Epyllion Style Ltd

6th May 2014

Observations

Actual First Floor slab layout

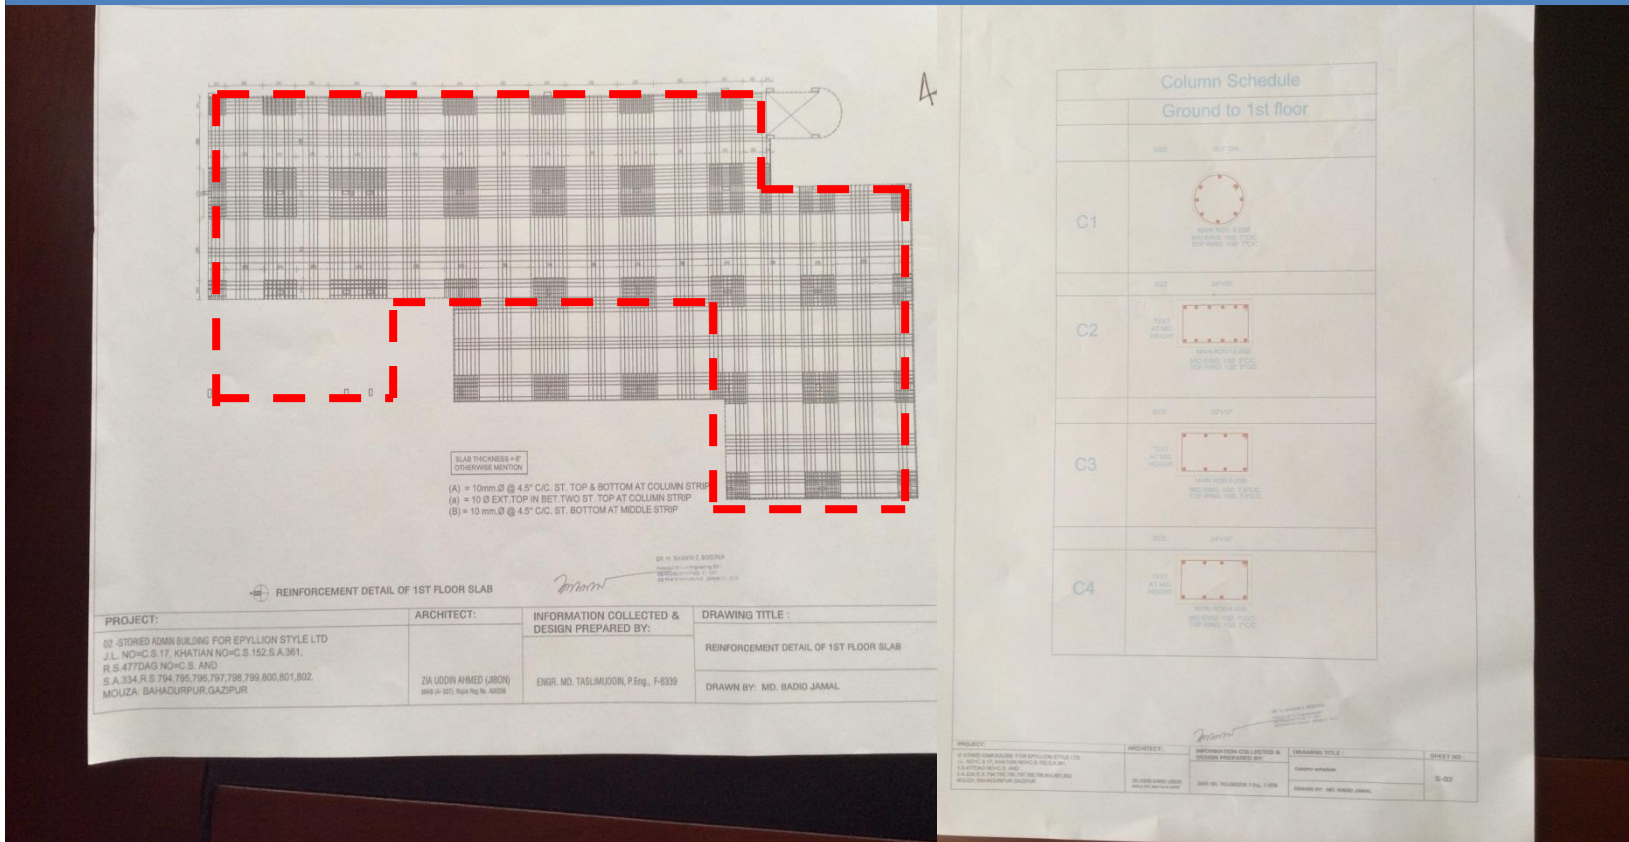
Inadequate structural drawings were provided for concrete section of Building 1. These consisted of a single reinforcement detail for first floor slab and stairs and a column schedule. The slab thickness shown on 1st floor slab reinforcement drawing was 150mm. The actual slab thickness measured including finishes was 300mm. The extent of 1st floor shown on the drawing is incorrect.
